Planning, Zoning and Building Department

BOARD ACTION REPORT – APPEALABLE ITEM

Project Name: The Grove Side Bar
Project Location: 183 NE 2nd Avenue
Request: Class III Site Plan Modification
Board: Site Plan Review and Appearance Board
Meeting Date: August 9, 2017

ITEM: **The Grove Side Bar (2016-250)** – Approval of a Class III Site Plan Modification associated with a change of use for The Grove Side Bar [Restaurant] with minor changes to the respective elevations, located at 183 NE 2nd Avenue

PROJECT NUMBER 11/2017
TITLE SHEET / SITE PLAN

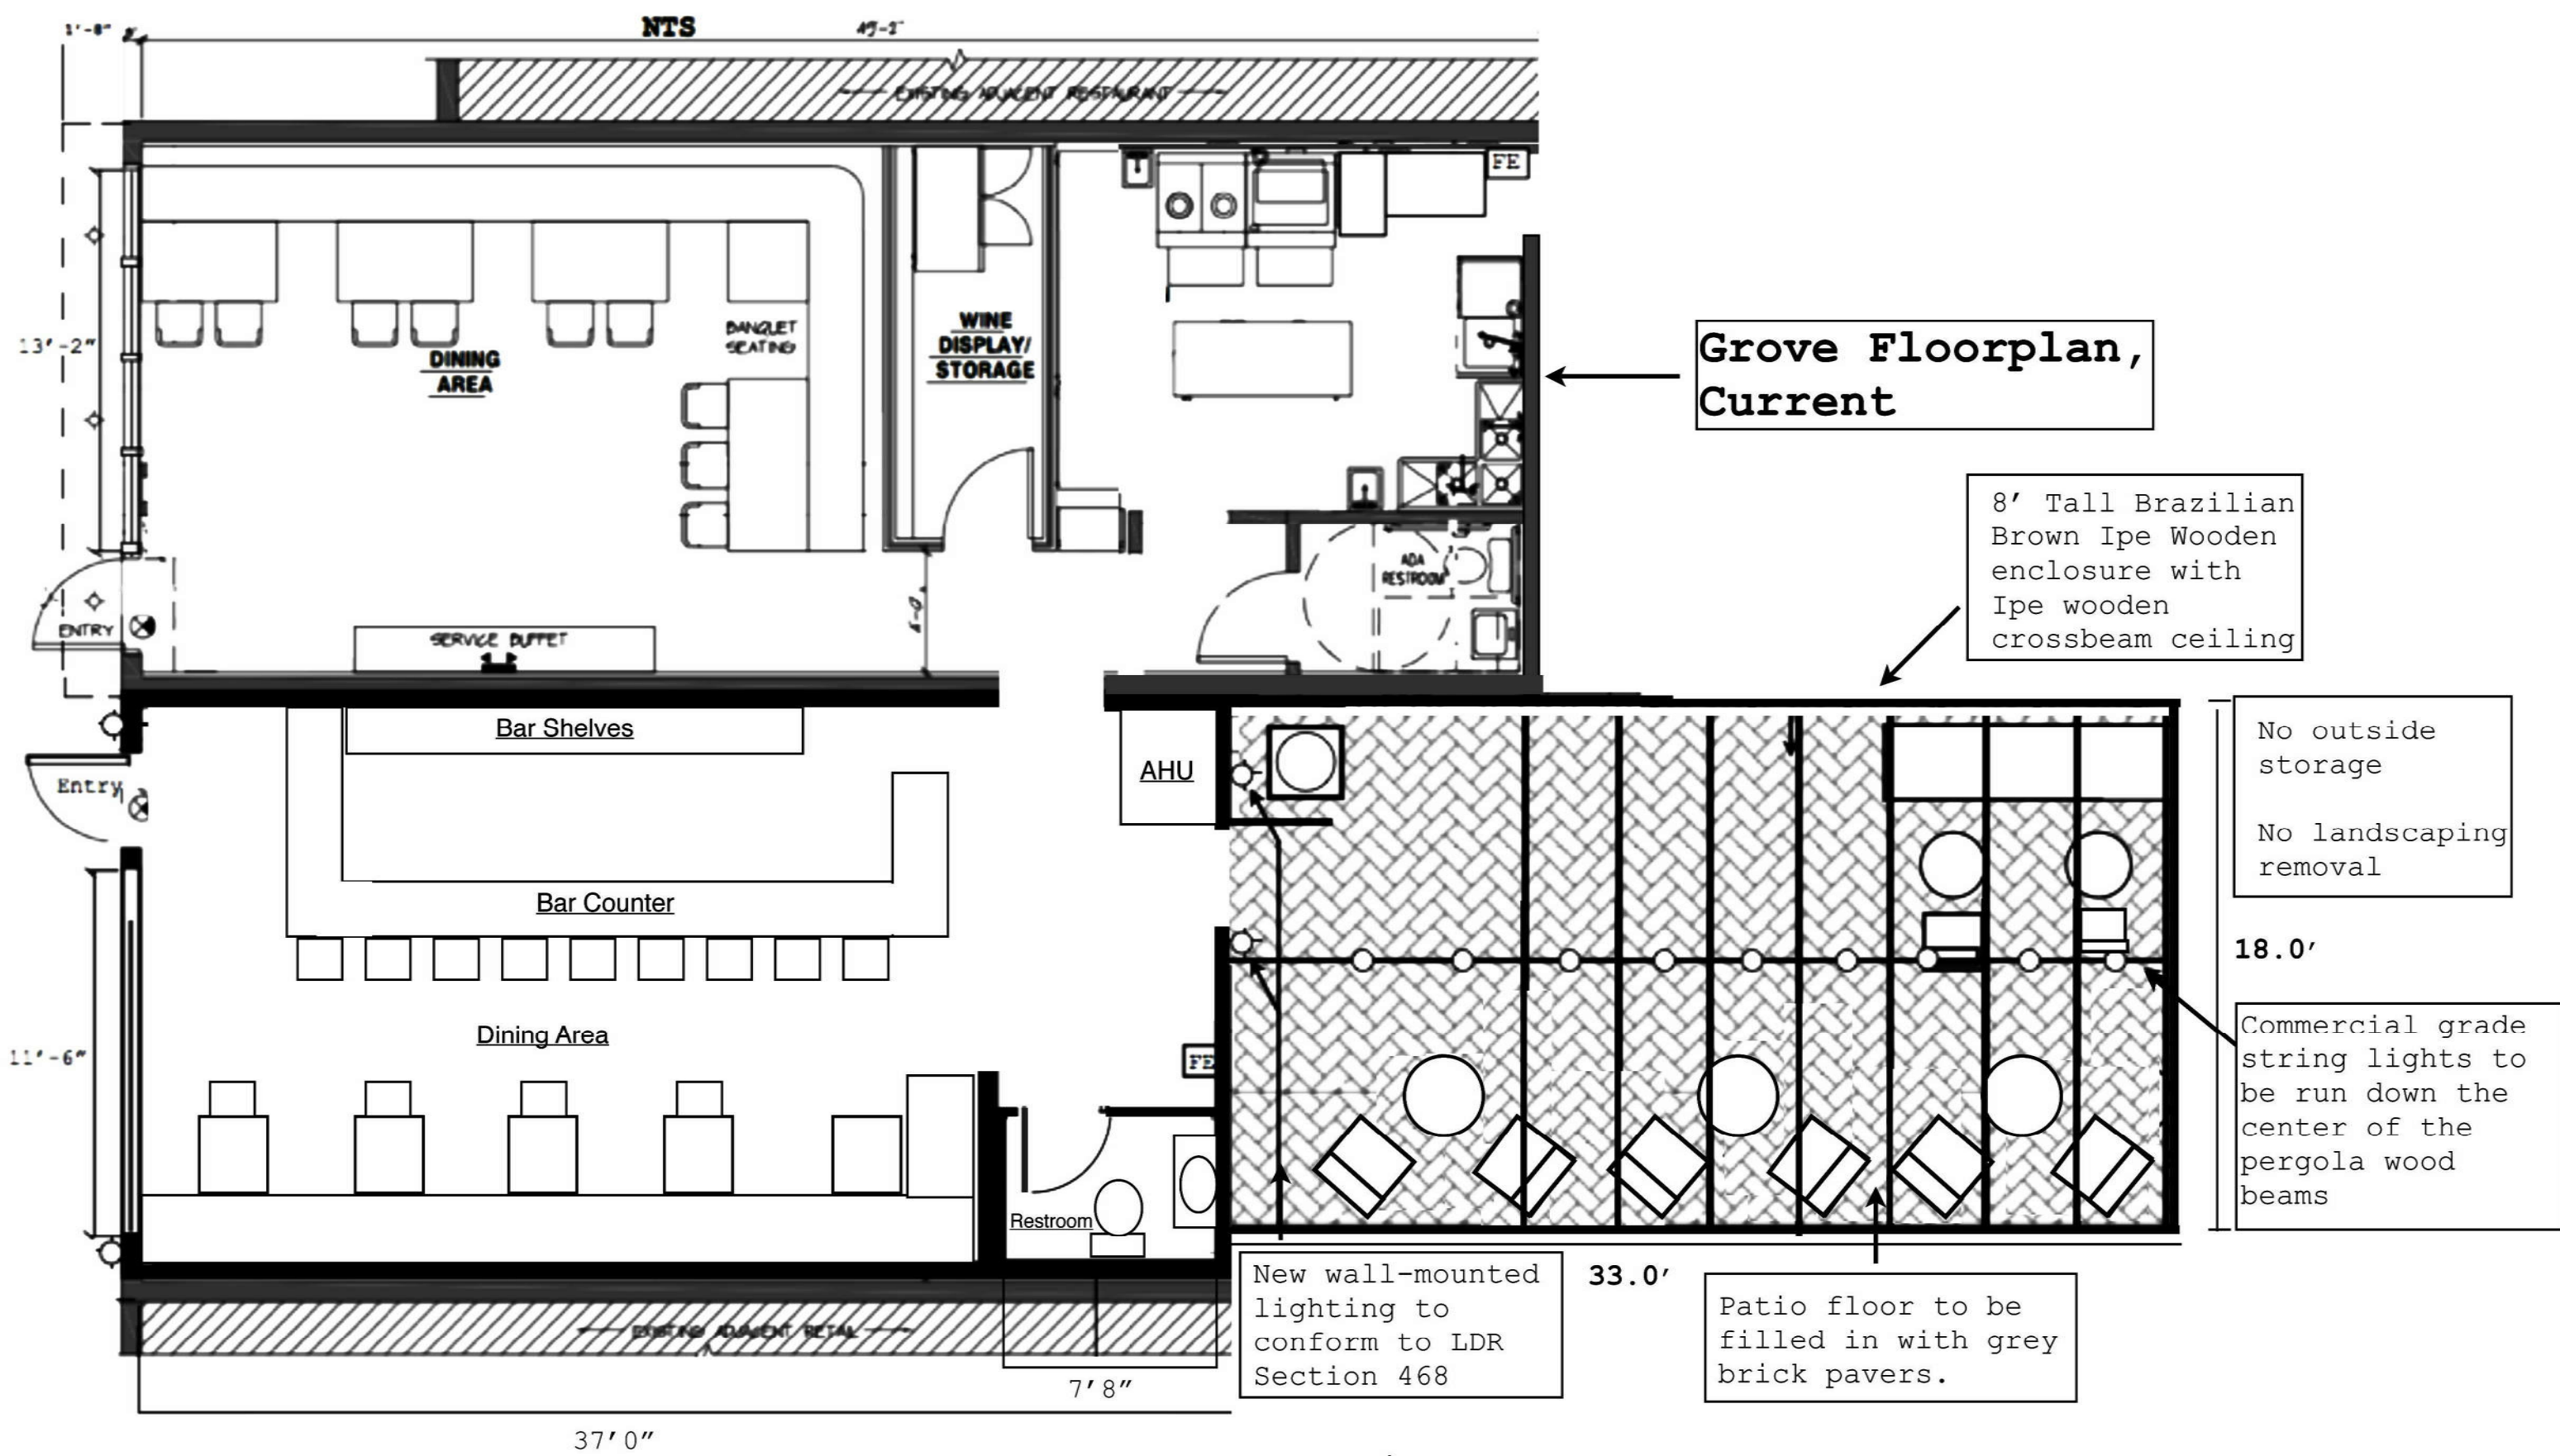
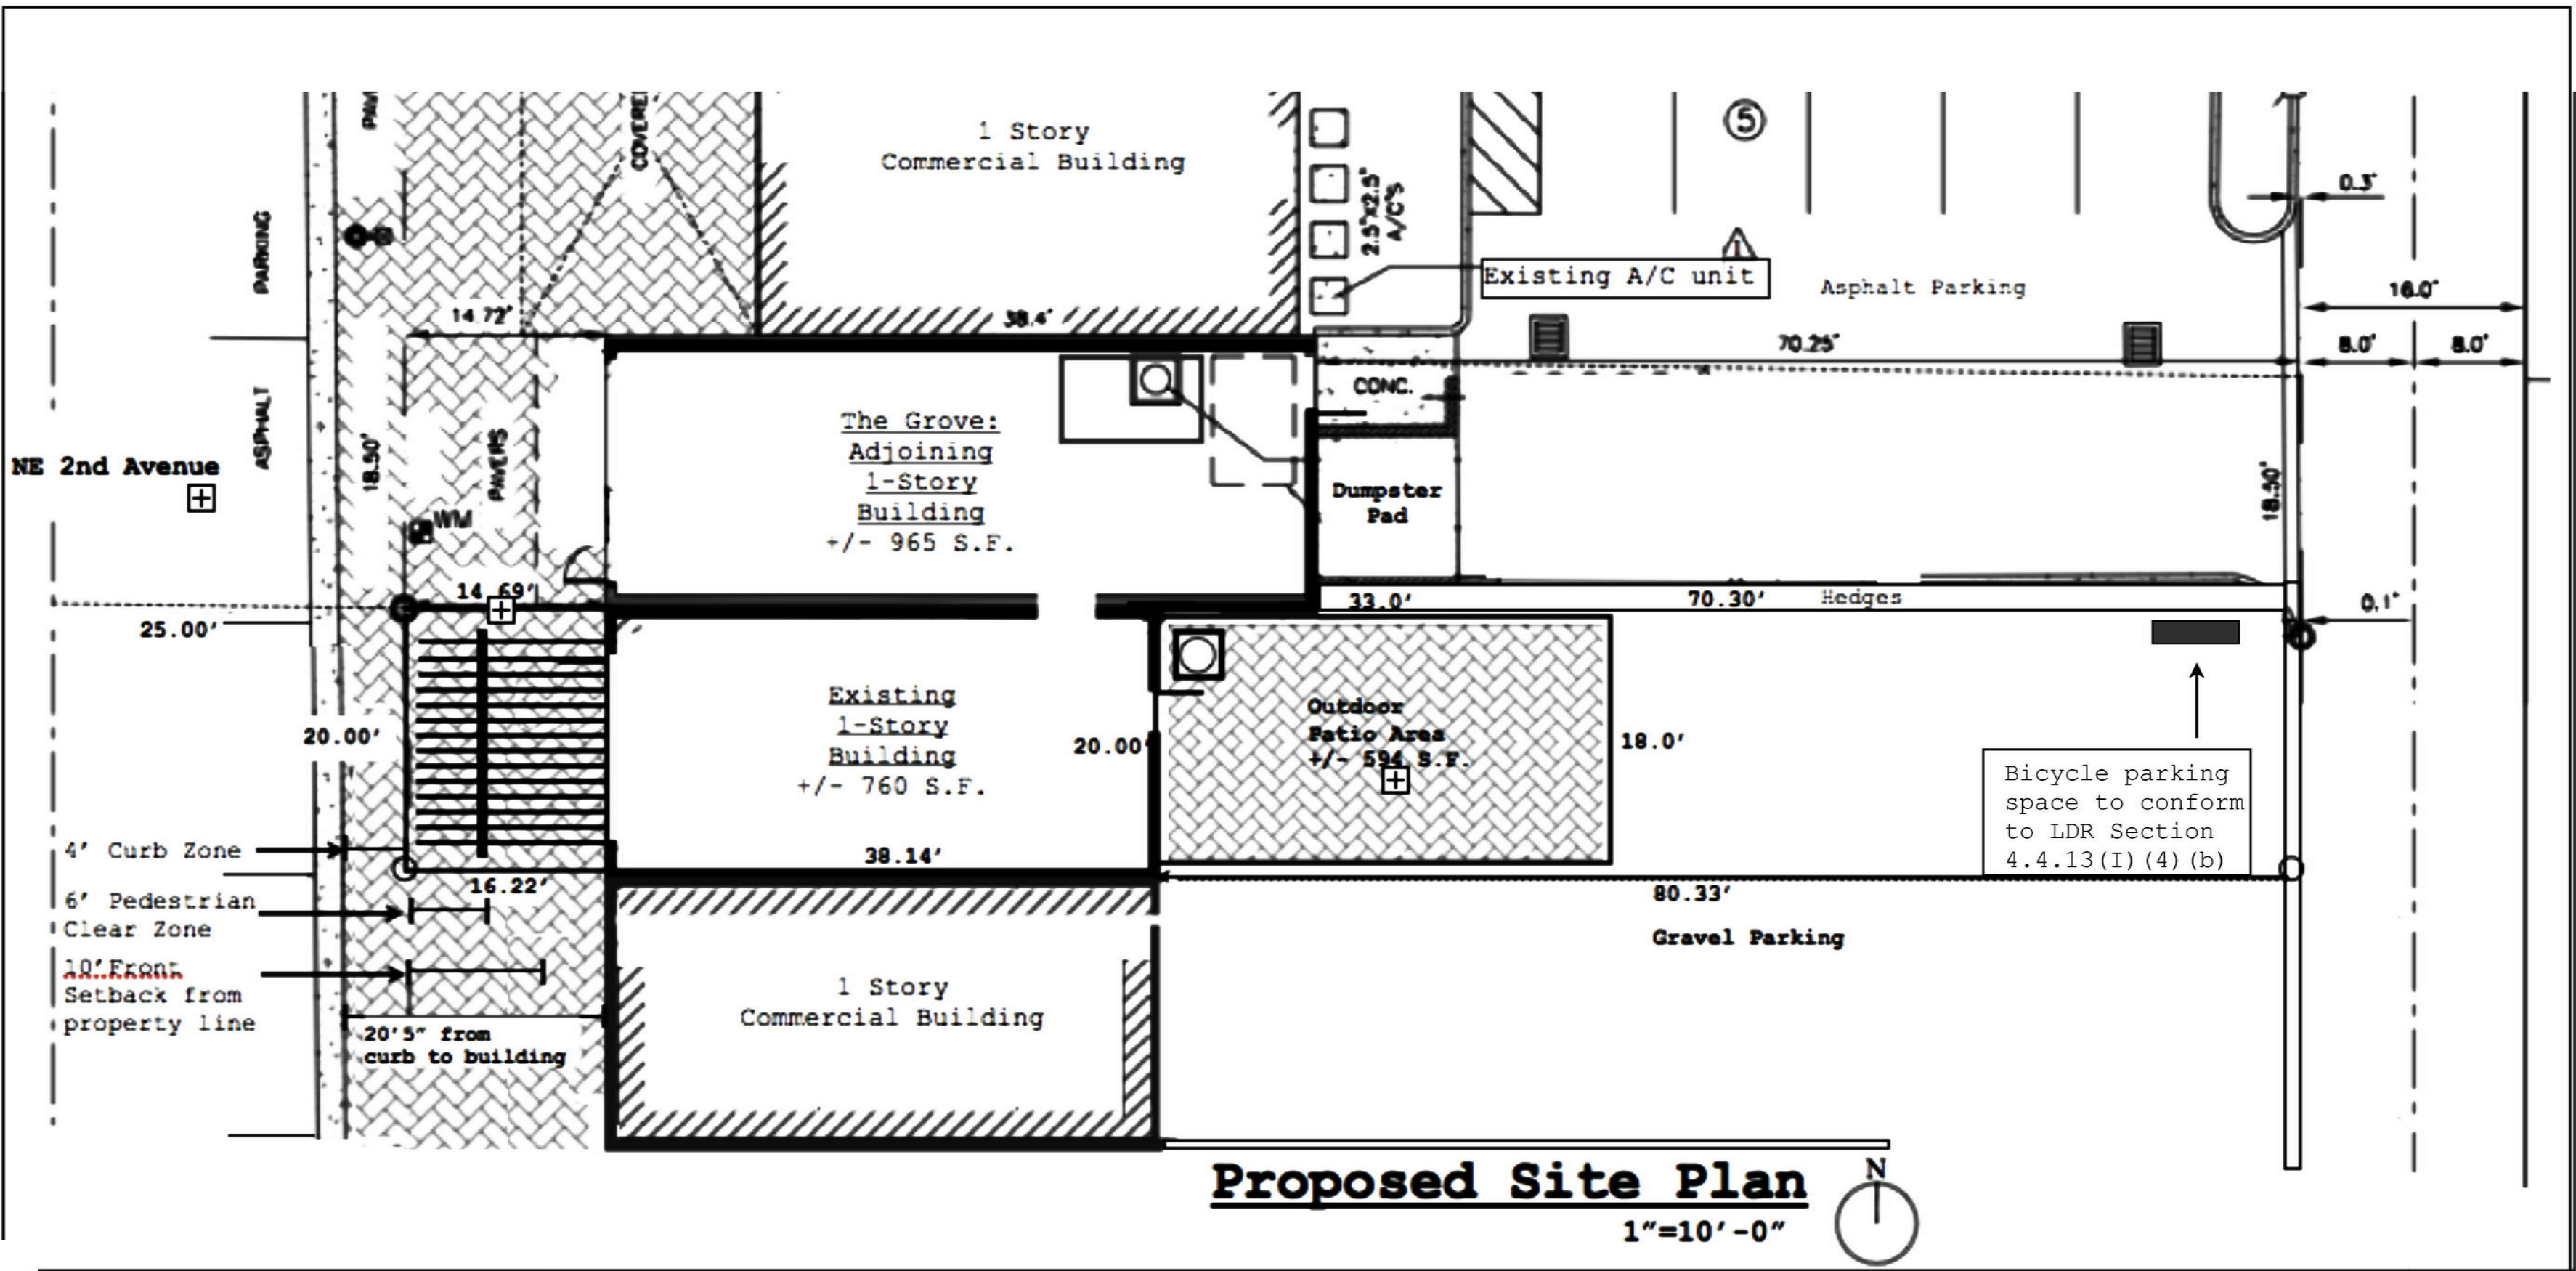
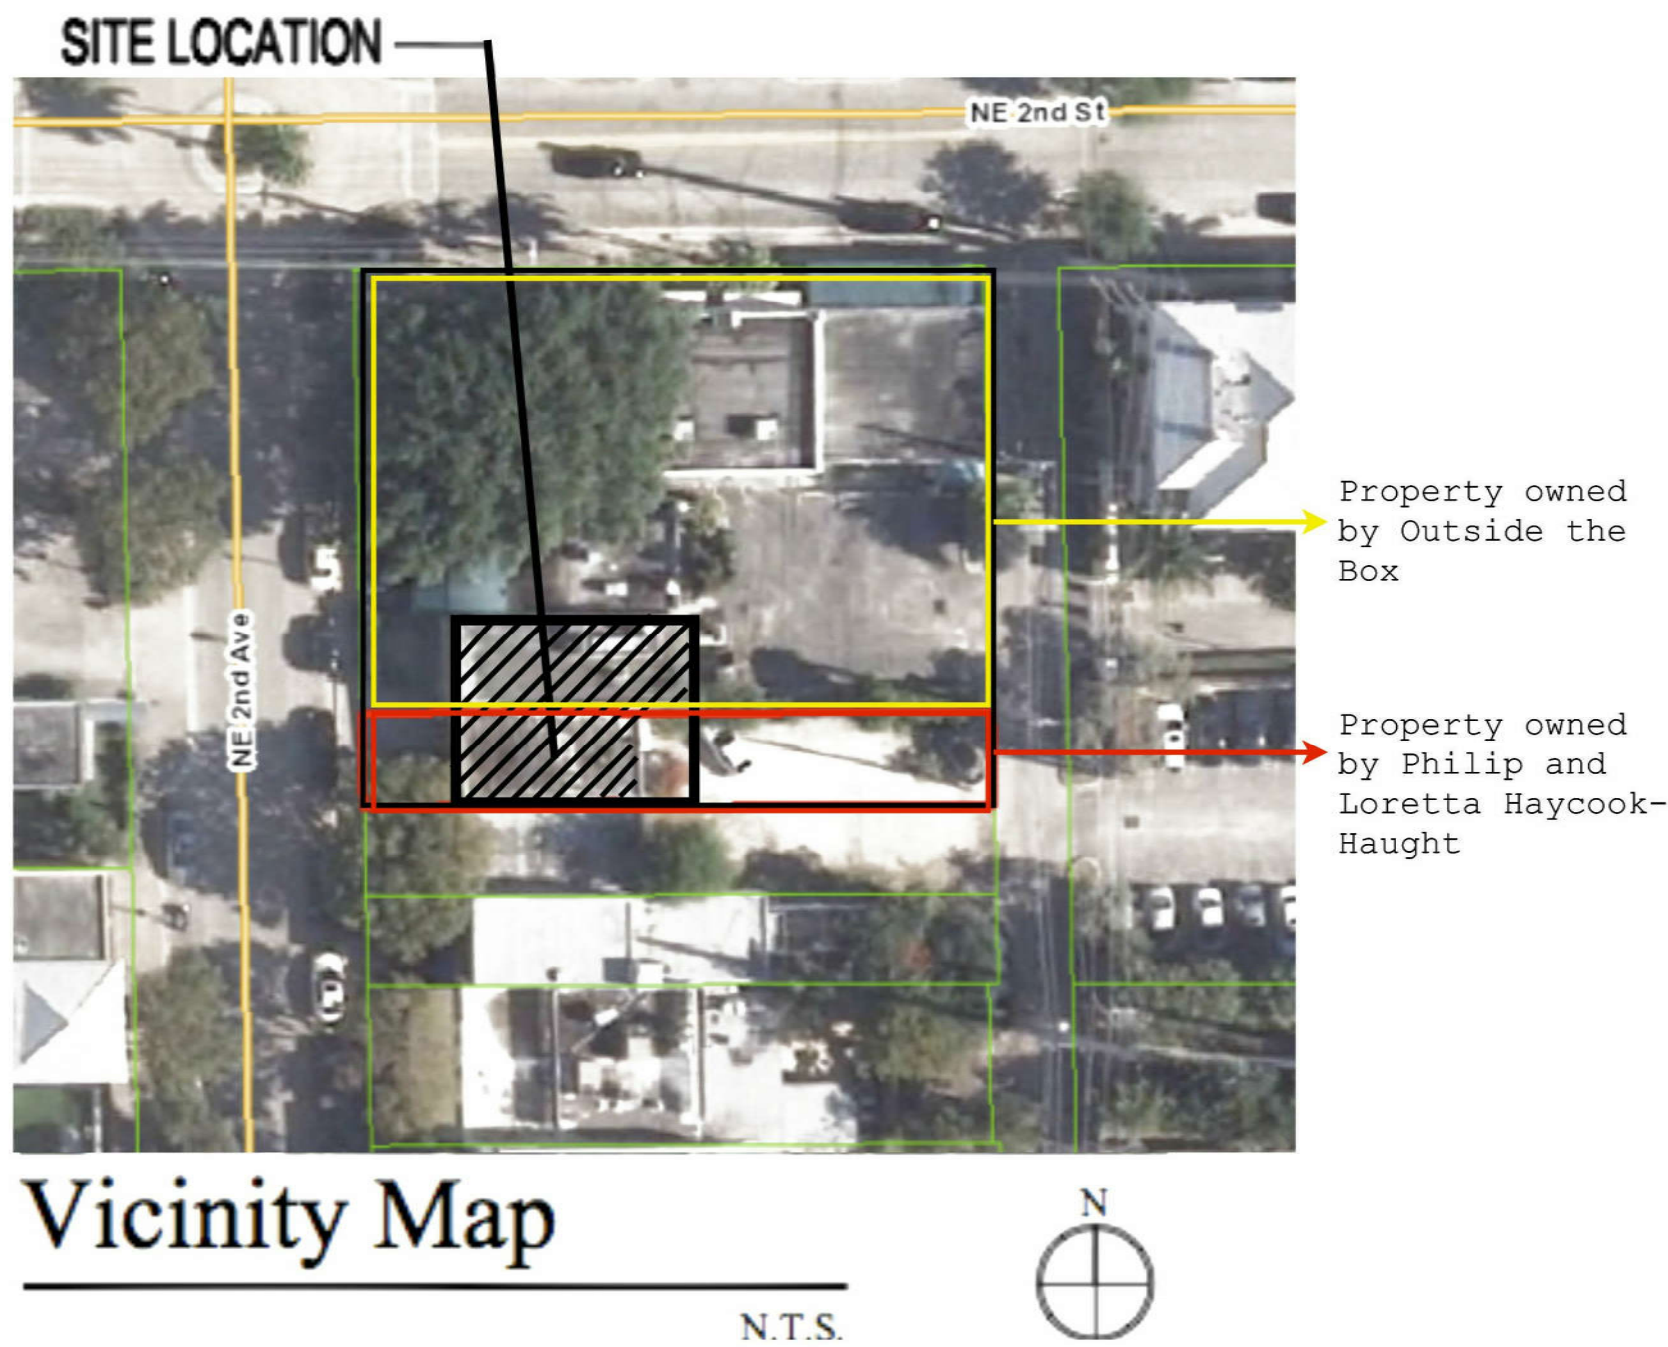
As noted on Sheet A0, the pedestrian clear zone encroaches into the subject property. A sidewalk easement for the 6 feet will need to be provided prior to issuance of a building permit and this is attached as a condition of approval.

It is noted that there is a significant distortion between the scale noted on the plans and the dimensions when engineers scaled is applied. The applicant was notified of this discrepancy during technical review of the project. The applicant responded by having the plans signed and sealed by an architect together with a letter certifying that the dimensions are correct and the distortions are due to printing. However, the current set of plans are from a different architect with no letter. A condition of approval is attached that a letter from the current architect is submitted that certifies the dimensions on the plans are correct and the distortions are due to printing.

1. Execute and record a Sidewalk Easement prior to issuance of a building permit;
2. That a letter be provided by the architect noting that the dimensions on the plans are correct and the distortions are due to printing.
